Decision Report

Application for Works Approval

Works Approval Number W6122/2018/1

Premises Beagle Bay Waste Water Treatment Plant

Figure 2 Existing and proposed new BWWTP
Works Approval: W6122/2018/1
File Number: DER2018/000033

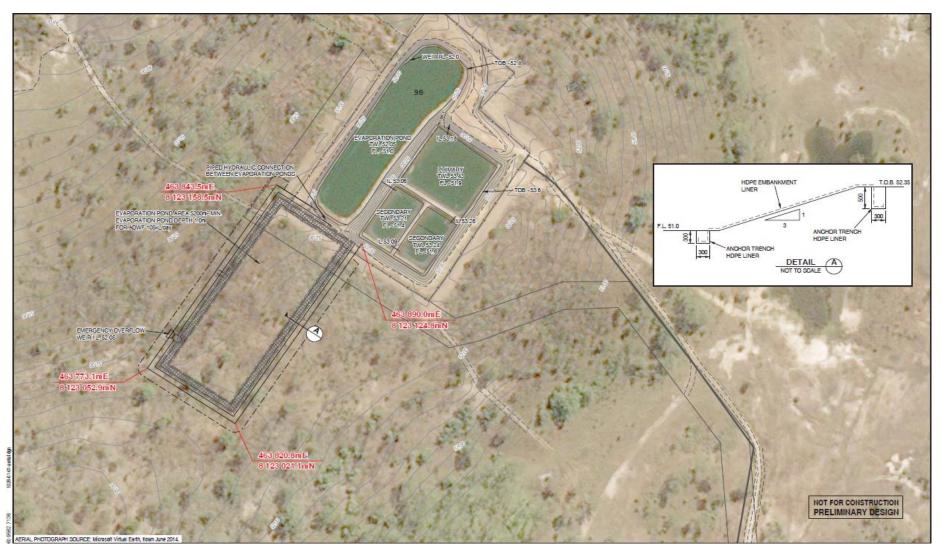
Figure 2 provides an overview of the existing WWTP and proposed new BWWTP. There will also be associated construction of pipelines and inlet mains etc. Construction of the new WWTP is to allow for the WWTP production and design capacity to increase from 80m³/day to 175m³/day to treat a balance capacity throughput of 110m³/day to service a maximum of 525 persons. The new Evaporation / Infiltration pond will be constructed to the southwest of the existing ponds. The proposed BWWTP is not designed to discharge untreated wastewater into the environment. Discharge of treated wastewater, which has undergone primary and secondary treatment, will only occur through infiltration to land in the two Evaporation / Infiltration ponds with the new additional Evaporation / Infiltration pond creating sufficient storage capacity so that overflows from the WWTP, as currently experienced, will cease. Table 4 provides the new BWWTP Evaporation / Infiltration pond dimensions.

Figure 4 Test pit locations

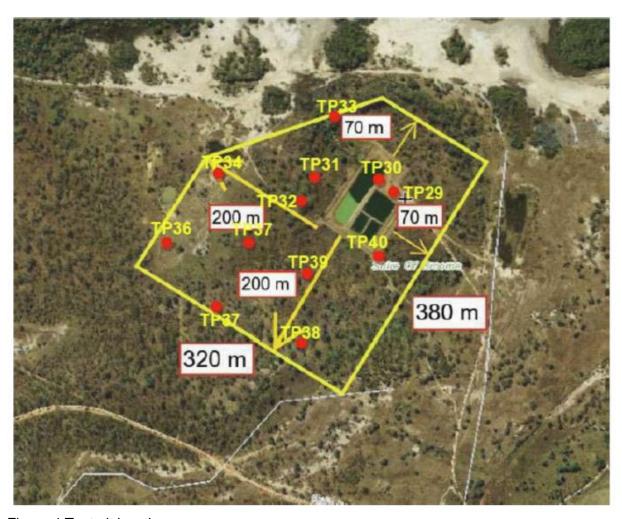
As part of the Application a geotechnical investigation was conducted by Local Geotechnics (January 2016) for the purpose of the BWWTP upgrade. The investigation included 12 test pits (TP29-TP40) in the planned WWTP expansion area; refer to figure 4 for an overview of the pit locations. Test pits where drilled to the target depth of 1.5m were possible. All soils were moist in the first stratum (0.4-0.5m) and occasionally moist or slightly moist at the lower stratum to 1.5m depth. The water table was not encountered in any test pit which was drilled to 1.5m depth. Test pit TP32 was laboratory tested as 86% sand, 14% non-plastic fines (silt) and the samples were poorly graded and almost no soil passed 2.36mm. Permeability testing results indicate permeability $K_{20} = 1.25 \times 10^{-7}$ m/s at 95%MMDD. Sandy soils have a high infiltration rate and water readily filters into the underlying strata and any overflow or infiltration

that seep into the soil will be filtered through physical, chemical and biological process to remove constituents in the effluent.

Attachment 1: Site Plan

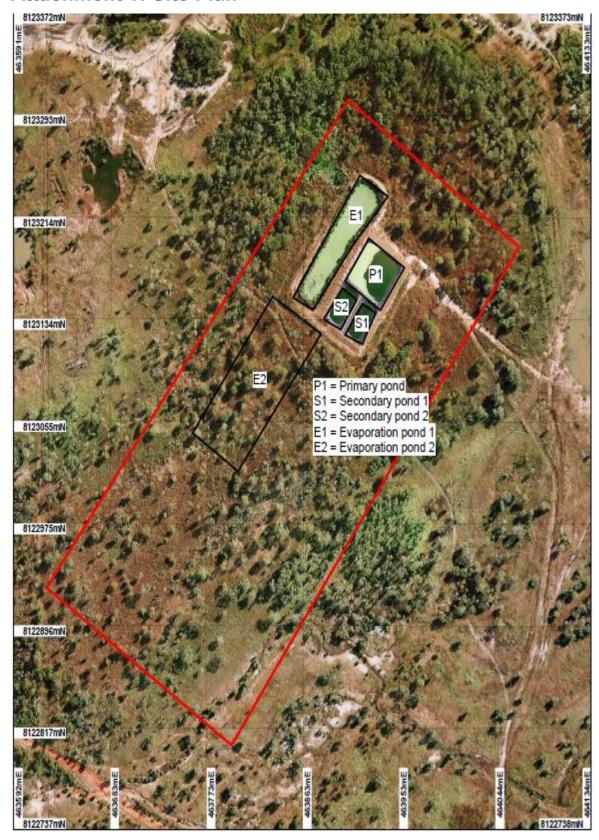
The sewage facility infrastructure, as it relates to Category 54 activities, is detailed in Table 7 and with reference to the Site Plan.

Infrastructure	Site Plan Reference
	Prescribed Activity Category 54	
Was	tewater Treatment Plant	
1	Primary pond	Attachment 1 Site Plan
2	Secondary pond 1	
3	Secondary pond 2	
4	Evaporation / Infiltration pond 1	
5	New Evaporation / Infiltration pond 2

Attachment 3: Clearing permit Plan

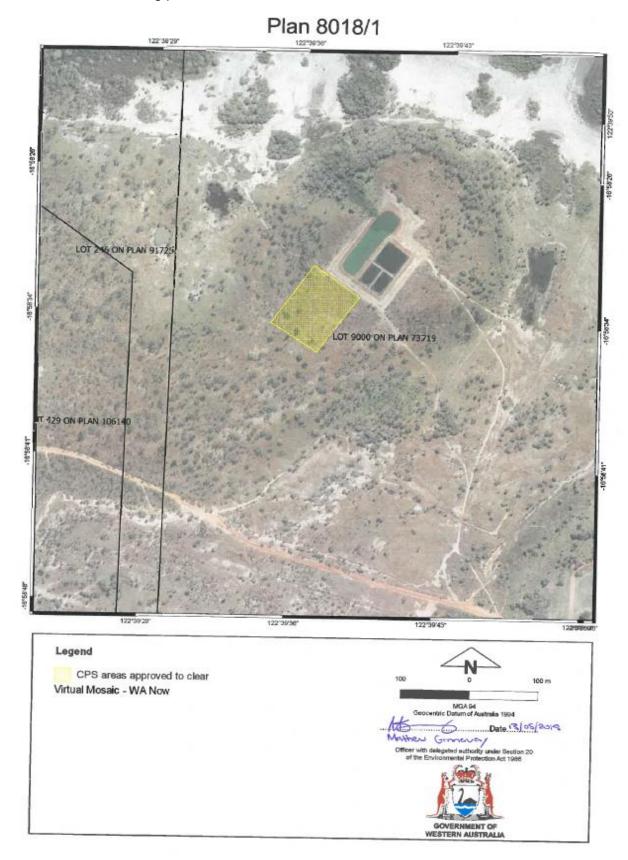
The works approval holder shall not clear more than 0.83 hectares of native vegetation within the area cross-hatched yellow on attached Plan 8018/1.
